## DEVIATION REVIEW AND DECISION FORM

Subdivision or Project Name: Falcon Marketplace

Revision Issued: SP-17-001 - Deviation #1 - Eastonville Road Full Access (Rev. 9-21-18)

Figure 1

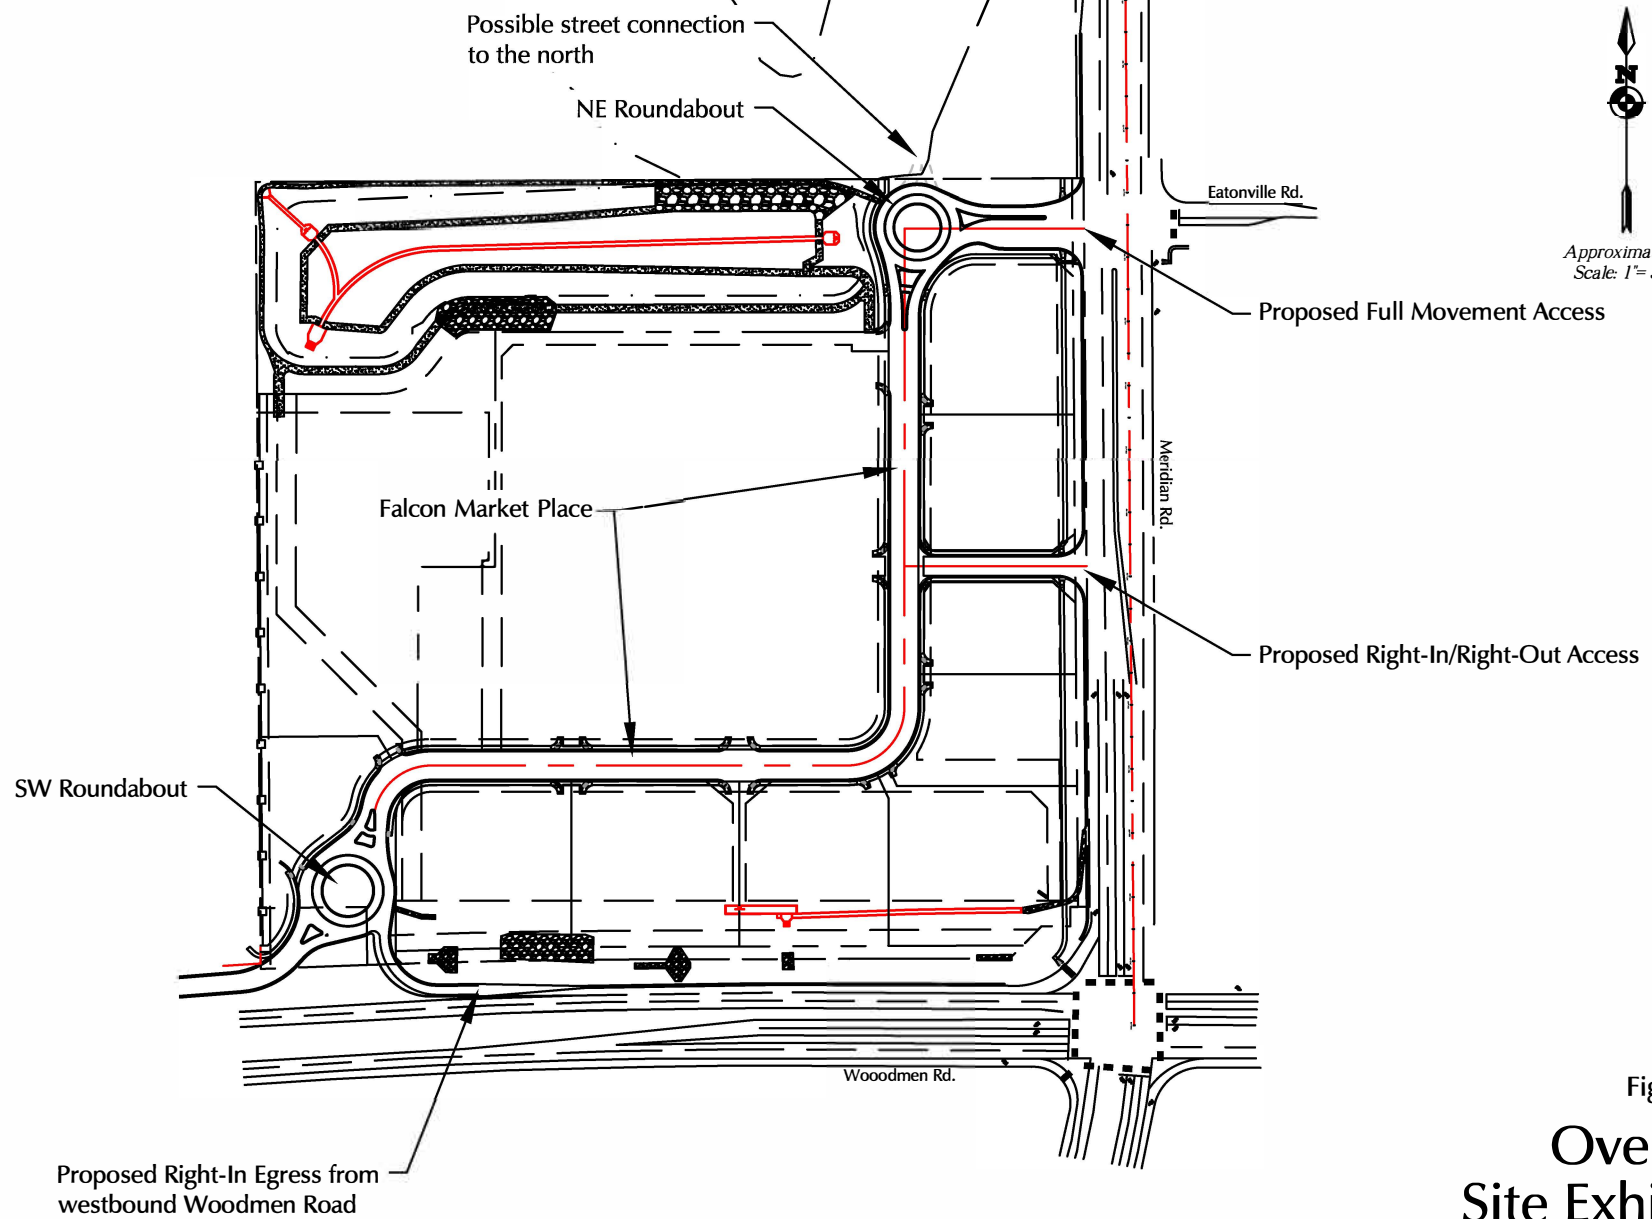
Proposed Nature and Extent of Deviation: The deviation is a request to allow a proposed full-movement access to Meridian Road (Principal Arterial) 1,245 feet (one-quarter mile) north of Woodmen Road aligning with Eastonville Road at the existing Meridian/Eastonville full-movement intersection.

Please refer to attached overall site exhibit.

This request has been determined to have met the criteria for approval. A deviation from Section 2.2.5.B.1 of ECM is hereby granted based on the justification provided. Comments:

- The proposed traffic signal shall be shown to meet warrants at the time of initiation.
- The proposed traffic signal shall be interconnected to and coordinated with the Meridian Road/Woodmen Road signal.

Figure 3

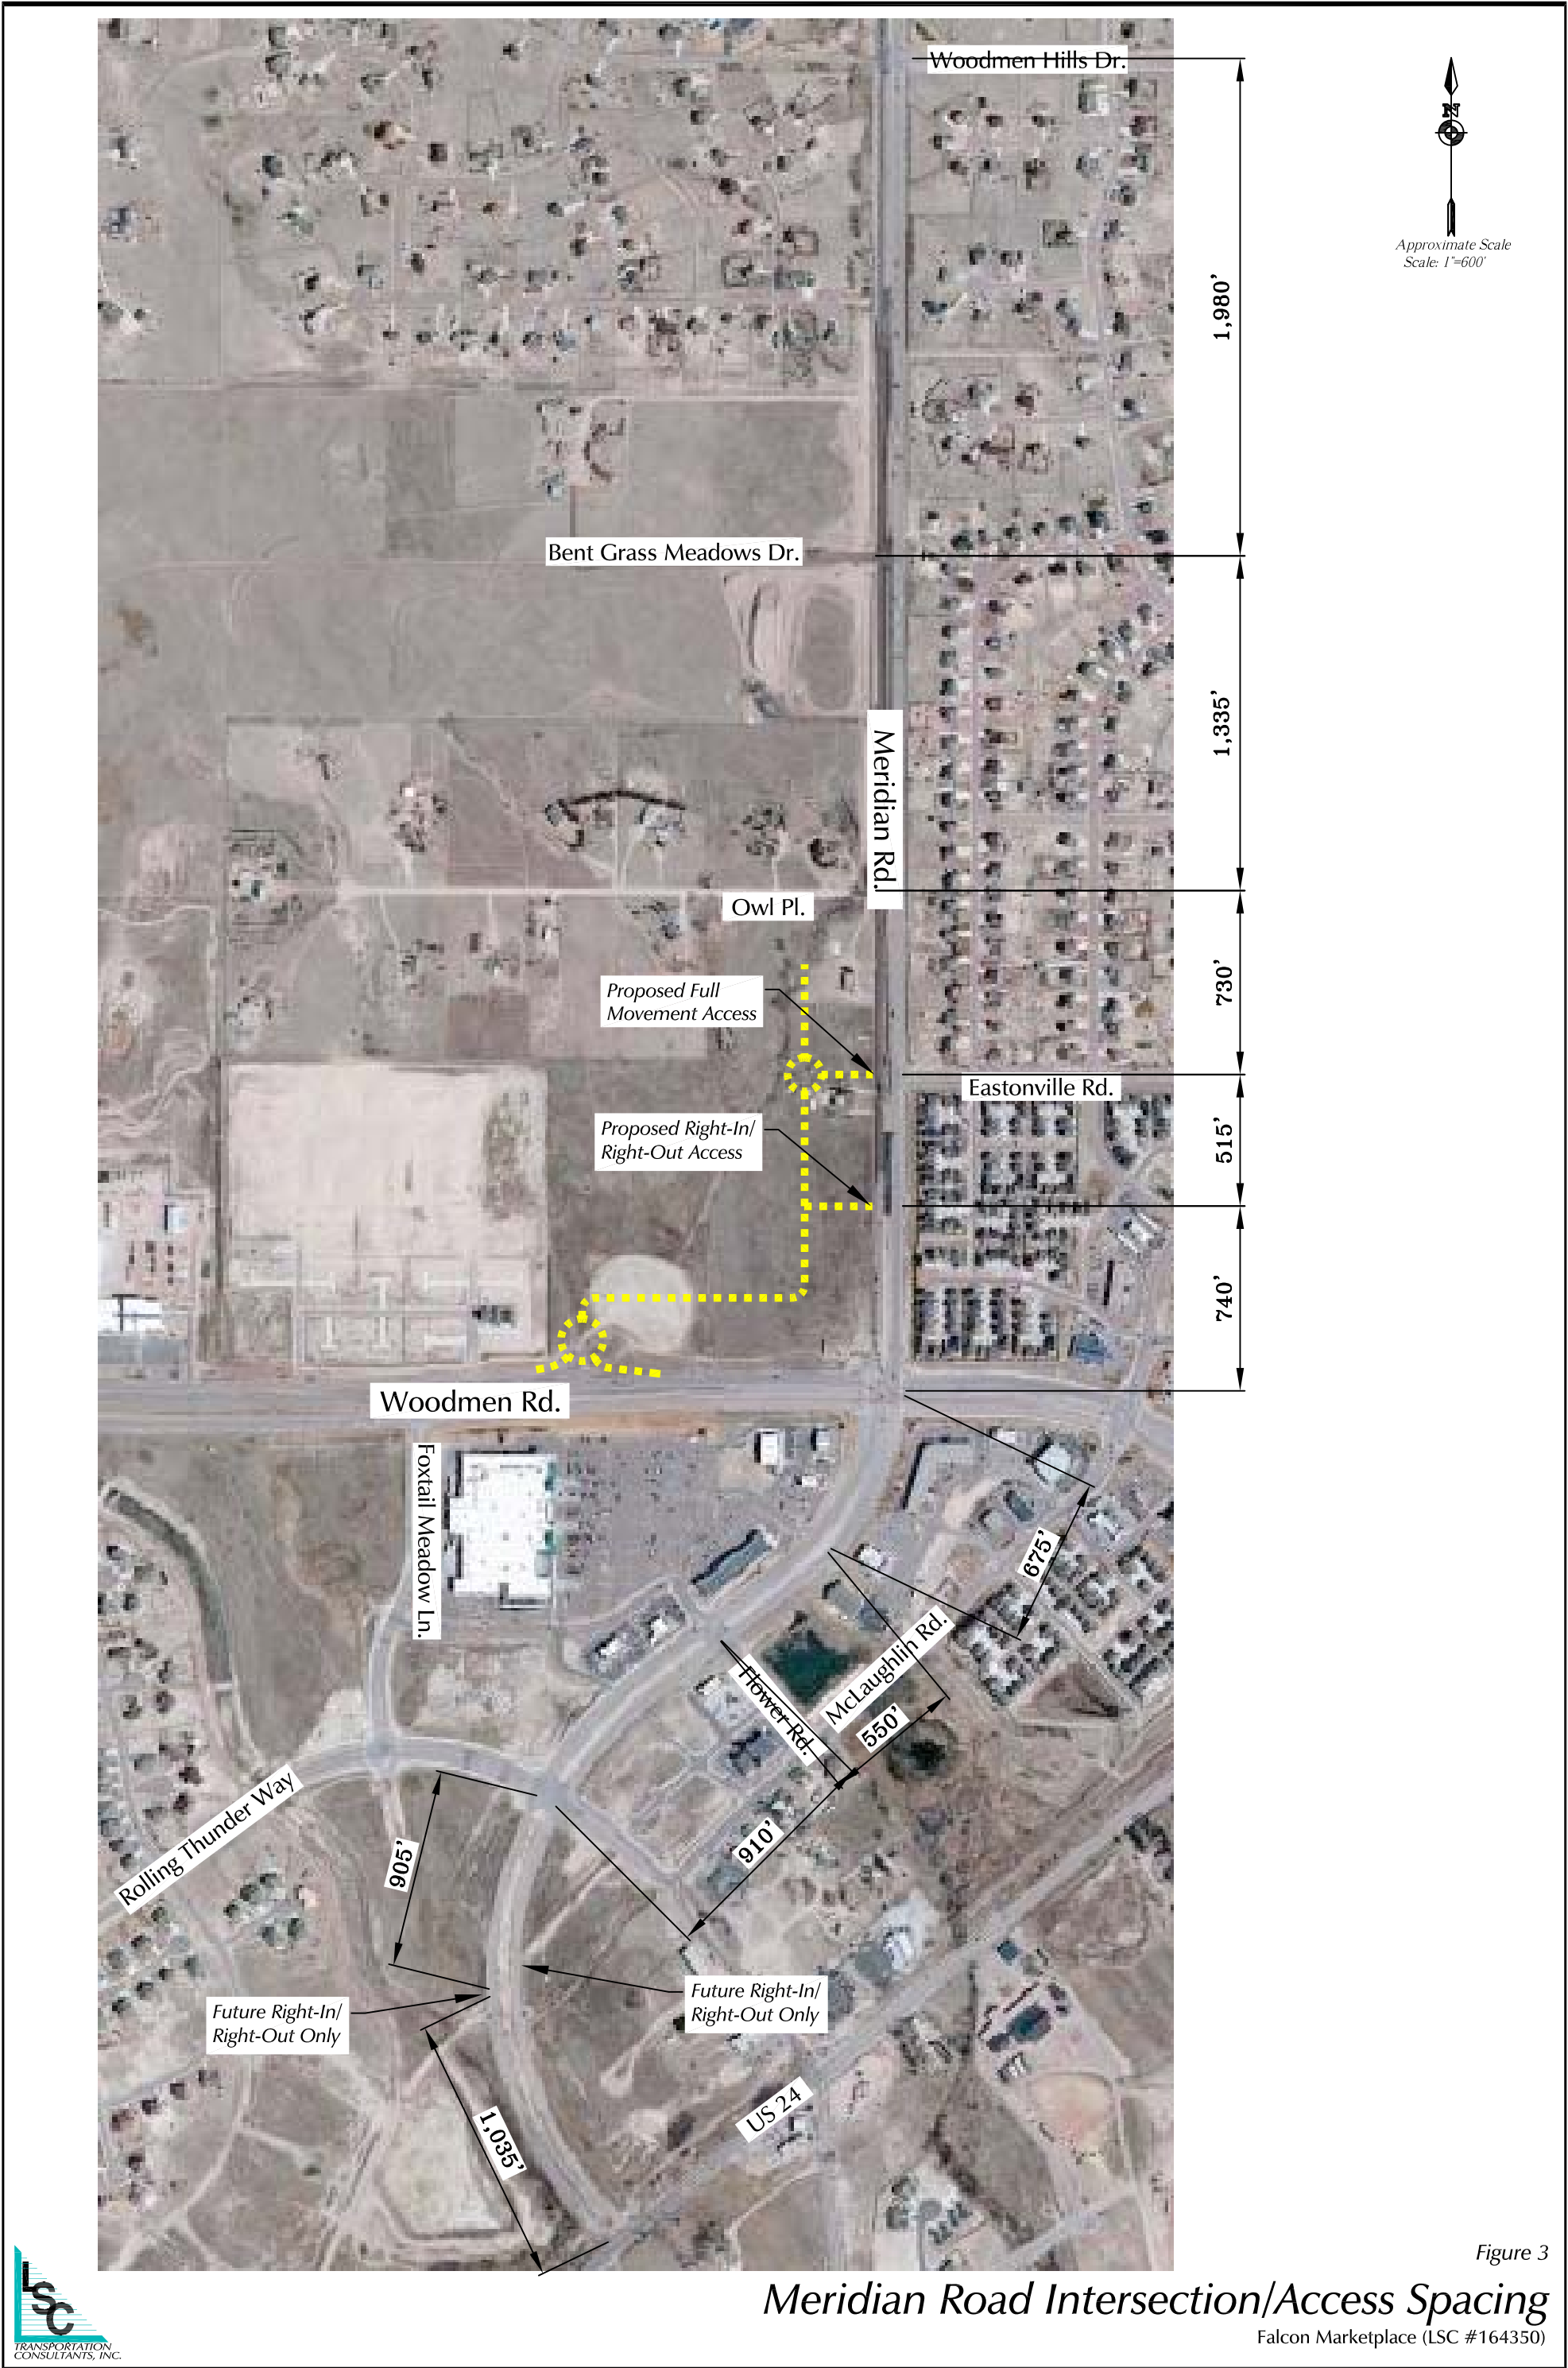
Please refer to the accompanying traffic impact study (TIS) for details and the traffic operations analysis. The TIS also includes exhibits requested by staff showing intersection/access spacing, acceleration and deceleration lengths and sight distance. The applicable exhibits are attached to this deviation.

Comparison of Proposed Deviation to ECM Standard: The access is 1,395 feet closer than the required one-half mile (2,640 feet).

Figure 23

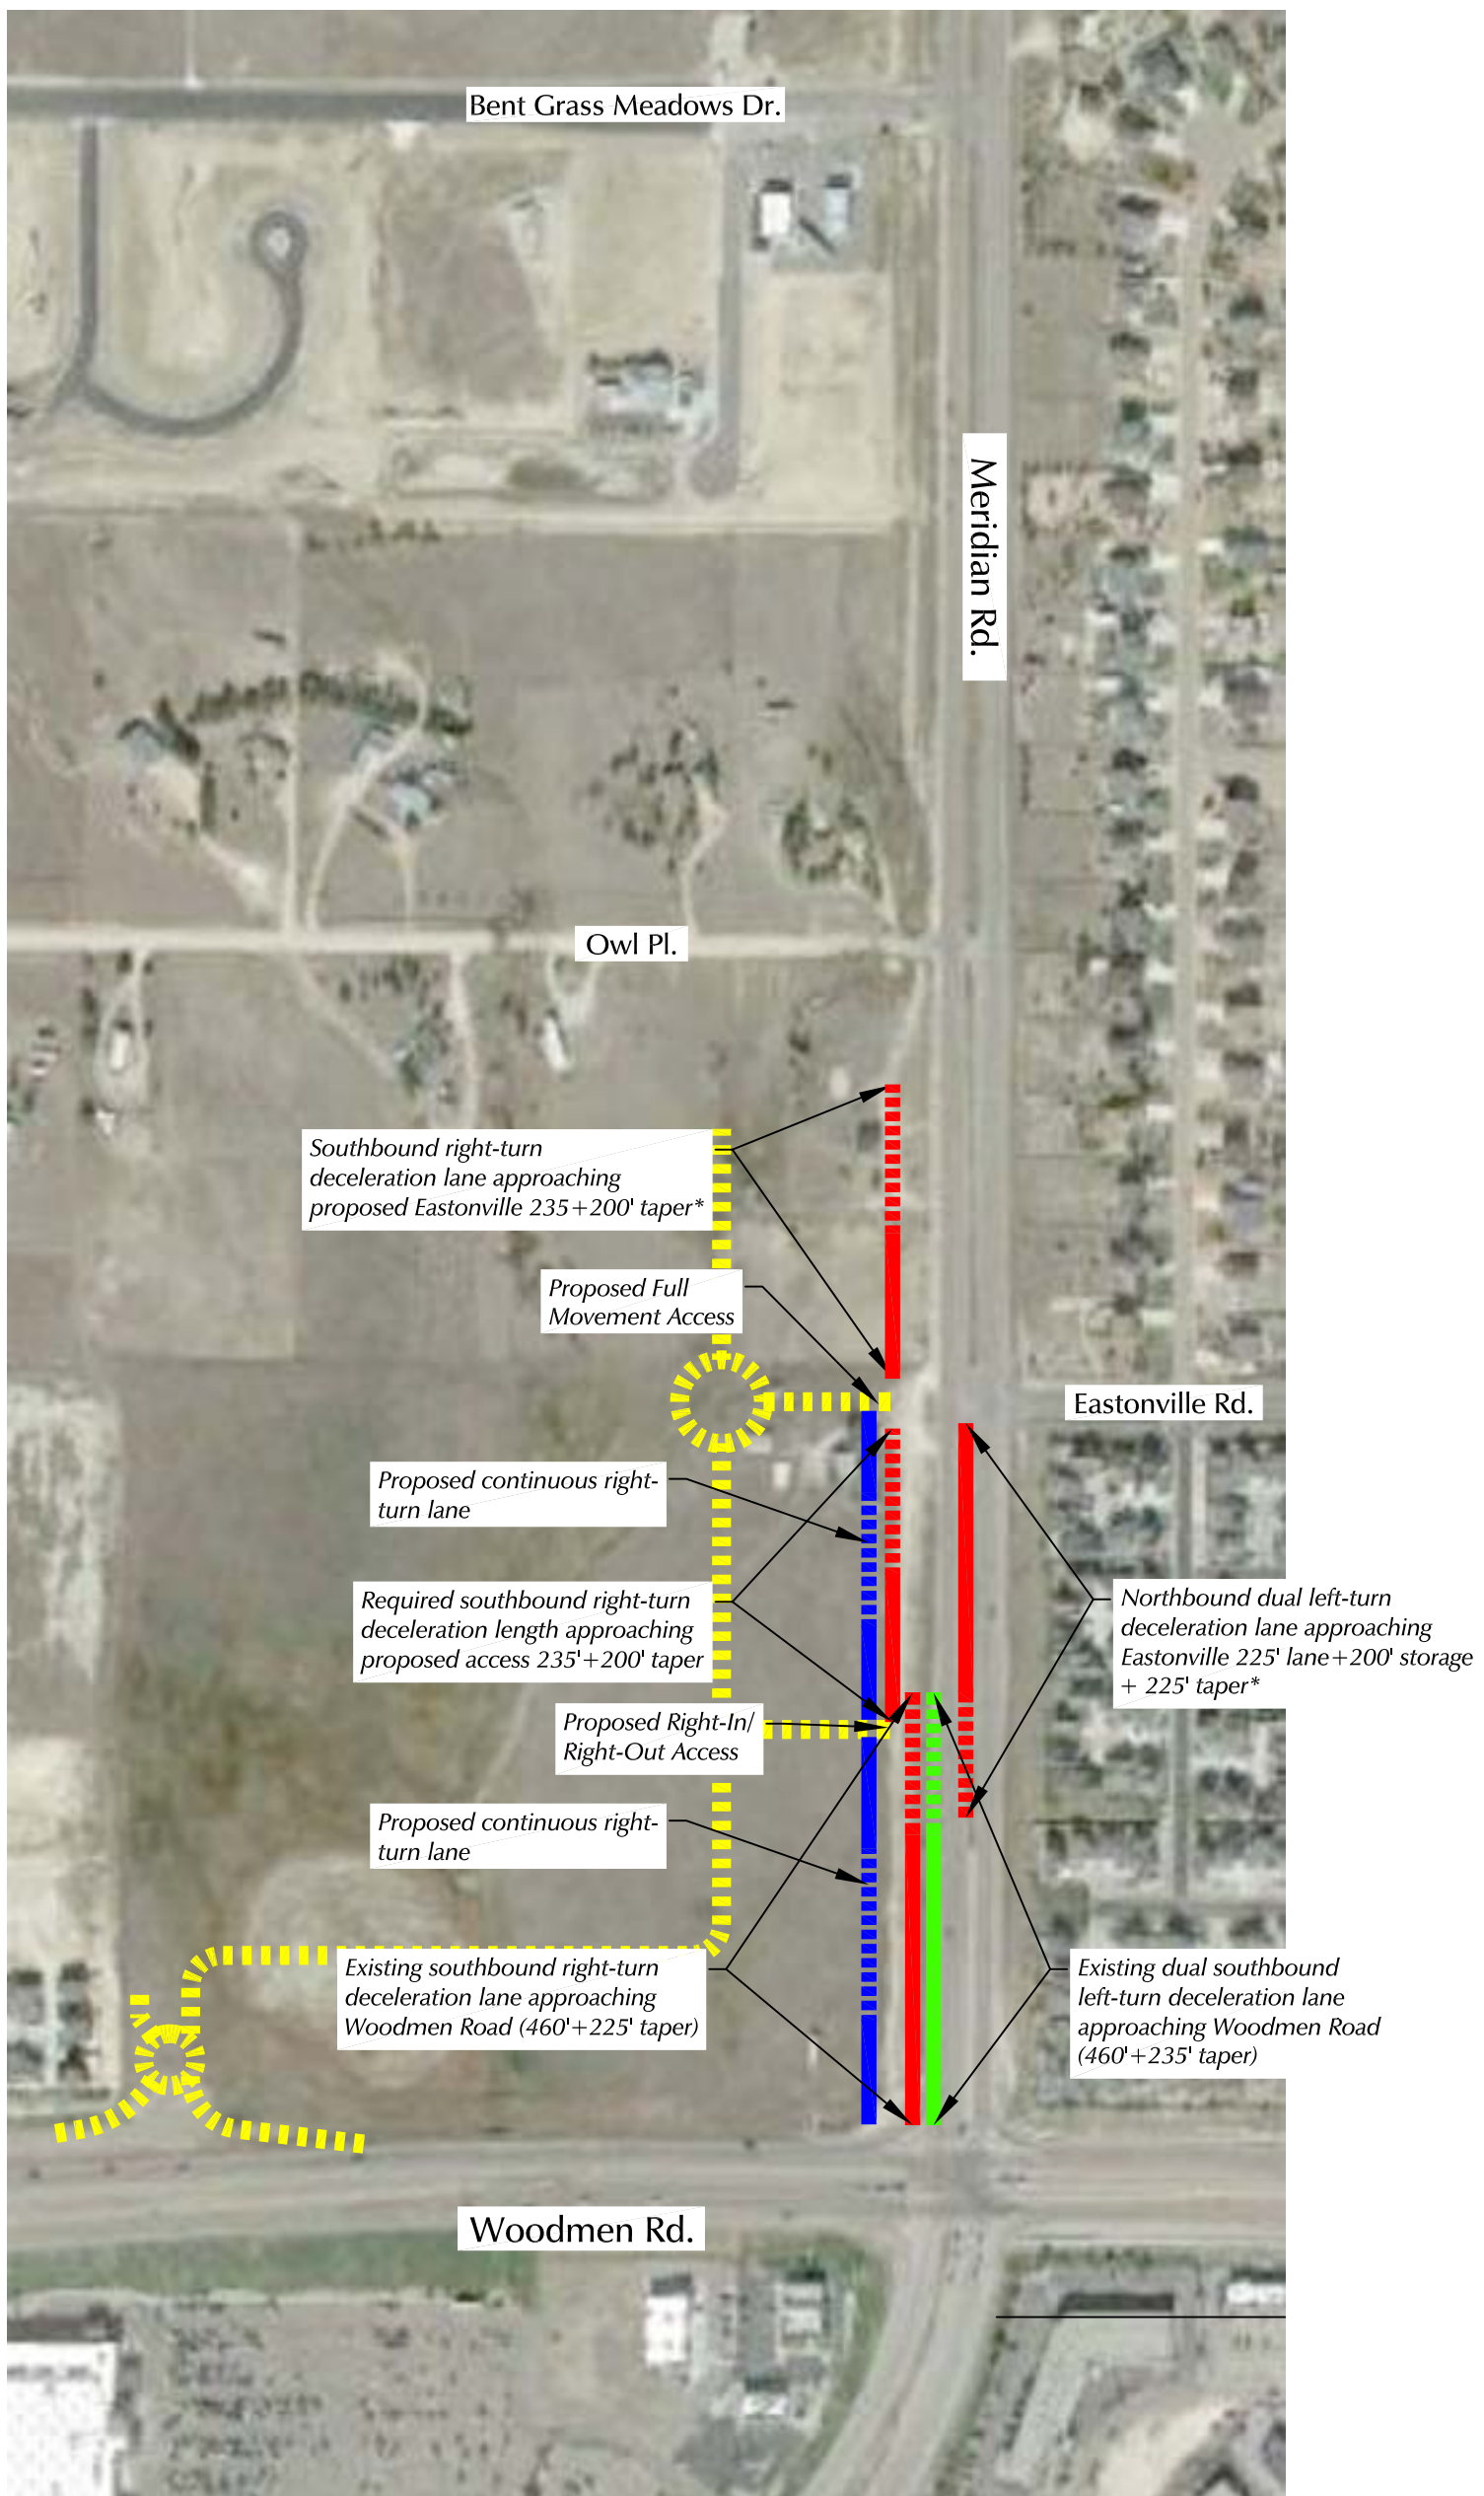
The request for a deviation is not based exclusively on financial considerations.	Cost is not a factor in this situation, the applicant is willing to bear the cost of roadway improvements necessary for the development and use of this site, and share in the cost of regional improvements at the described intersection.
The deviation will achieve the intended result with a comparable or superior design and quality of improvement. The deviation will not adversely affect safety or operations.	The "Meridian Road (North) Corridor Plan" (December 2009) recommends a west extension of Eastonville creating a full-movement access on the west side of Meridian to serve commercial development. The deviation for the one-quarter mile spacing, as opposed to the one-half mile spacing, would not adversely affect safety or operations. This is already a full-movement intersection. Left- and right-turn deceleration lanes will be provided.
